BAYPORT PLANNING COMMISSION

RE: Bayport: Hidden Shores Development
SEH No. A-BAYPO0703.00

RE: Hidden Shores Development
SEH No. A-BAYPO0703.00 14.00

CONCEPT PLAN OF HIDDEN SHORES, ADJACENT TO THE INTERSECTION OF WASHINGTON COUNTY STATE AID HIGHWAYS 21 (STAGECOACH TRAIL NORTH; CSAH 21) AND 14 (47TH STREET NORTH; CSAH 14 [WEST OF STAGECOACH TRAIL])

C1.2

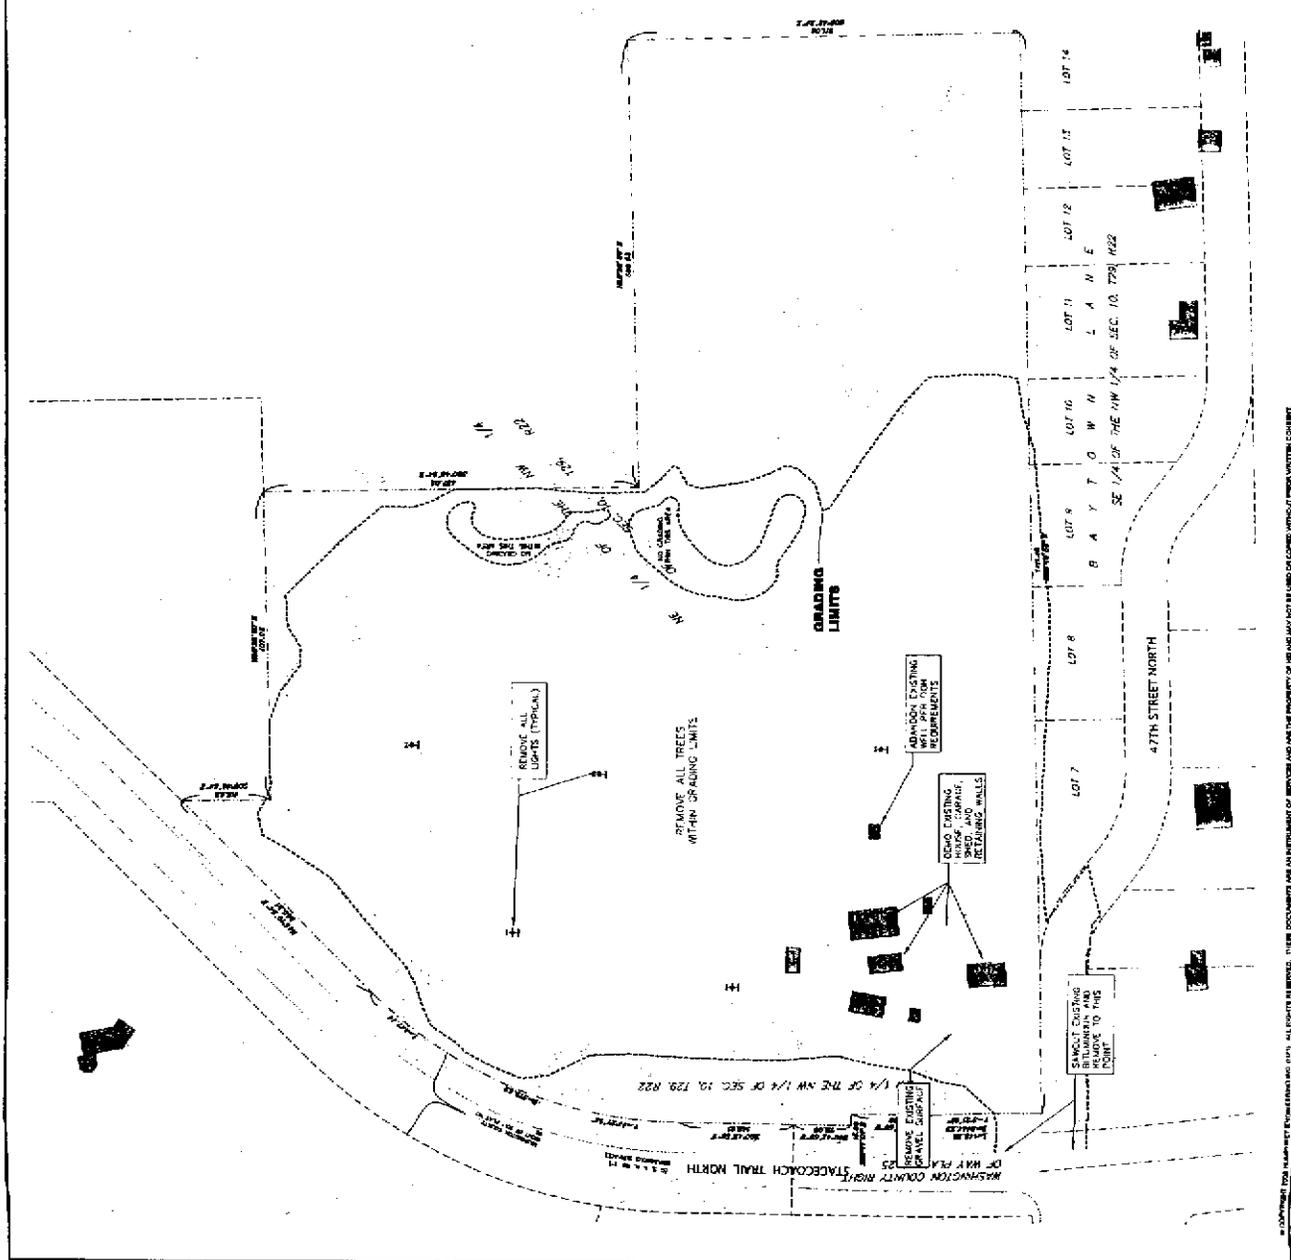
2. Sheet C1.2 Removal Plan

- Show Washington County Storm Sewer along Stagecoach Trail, north of 47th Street North.
- Grading limits shown across several lots in the Baytown Lane development to the south. Easements will be required and copies submitted to the city for their files.

C3.1

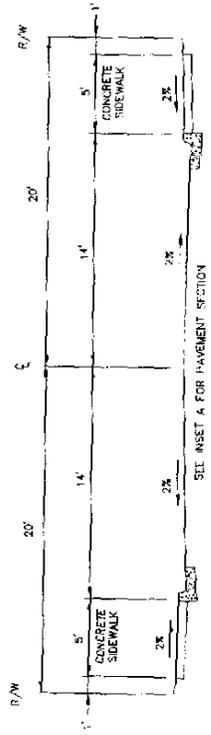
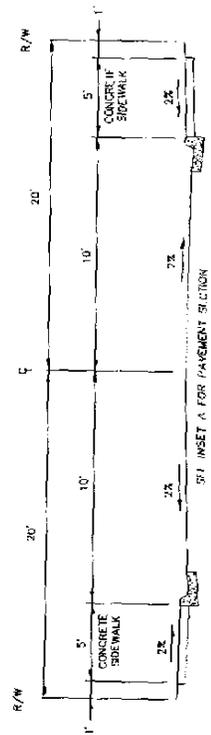
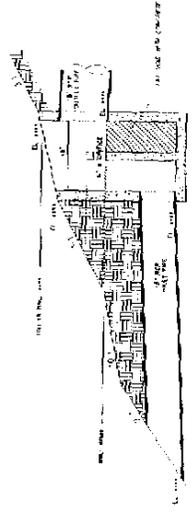
6. Sheets C3.1 through C3.4 Details

- Typical Sections, show minimum 50 foot right-of-way.
- Bituminous trail should be a minimum 8 foot in width, wider for pond access. Section for pond access should be beefed up to handle maintenance equipment.
- B6 style curb is proposed. How will driveways be installed? Will all be staked?
- Hydrant detail should include the note for the Storz hydrant nozzle.
- Hydrant detail will not work as shown. Five foot sidewalk behind curb.
- All gate valves to have a valve extension to within 2 feet of the surface.
